# Berkeley County Public Service Water District

## RT 38 BLAIRTON ROAD 12" AND 16" PARALLEL DISTRIBUTION SYSTEM IMPROVEMENTS ADDENDUM NO. 2 November 8, 2018

## 4" BLOW-OFF SETTING

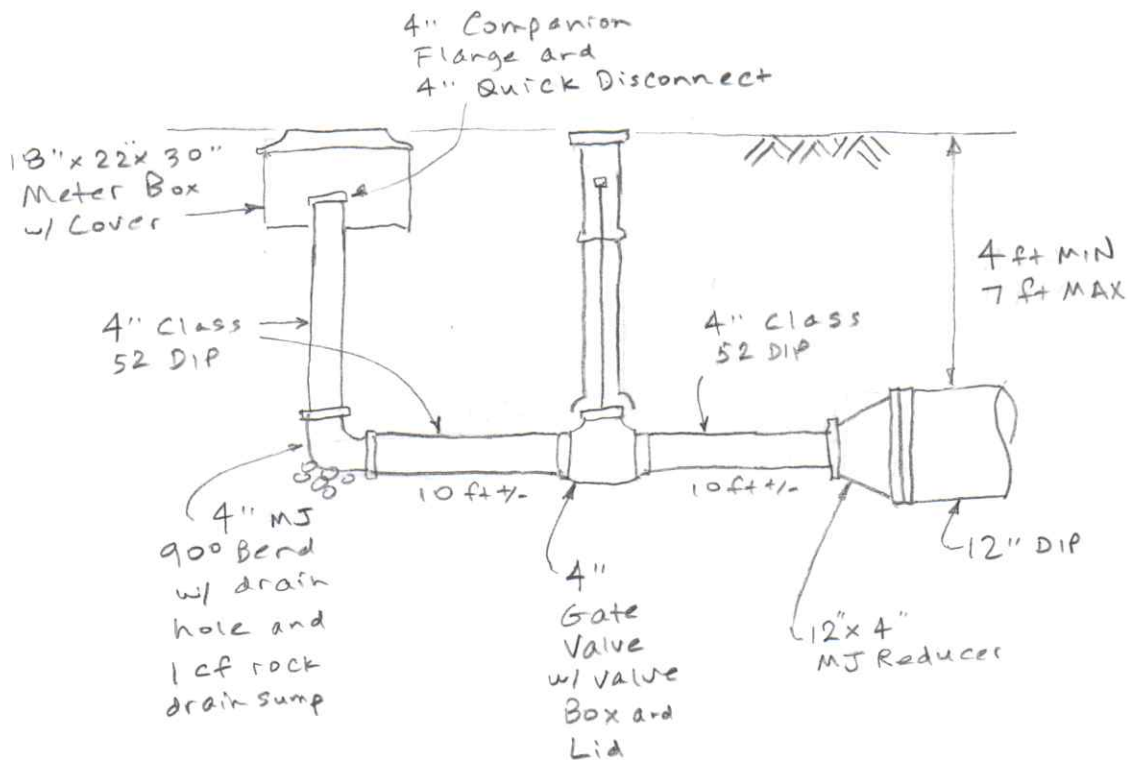
8. **Question:** The Drawings do not provide a detail for the 4-inch blow-offs shown on Drawing 5. Where are the 4-inch blow-offs shown on the bid form?

**Answer: The 4-inch blow-offs are called out at the end of the project on Golf Course Road. Bid item number 16 includes the 4-inch blow-off. Attached is a detail for this bid item. There is no cap required on the 12-inch main.**

1. All-thread rod the 4" MS 90° Bend to the 12" x 4" MS reducer.
2. Provide MEGALUGS on each fitting and valve.
3. Supply 50 feet of new hose to the District.
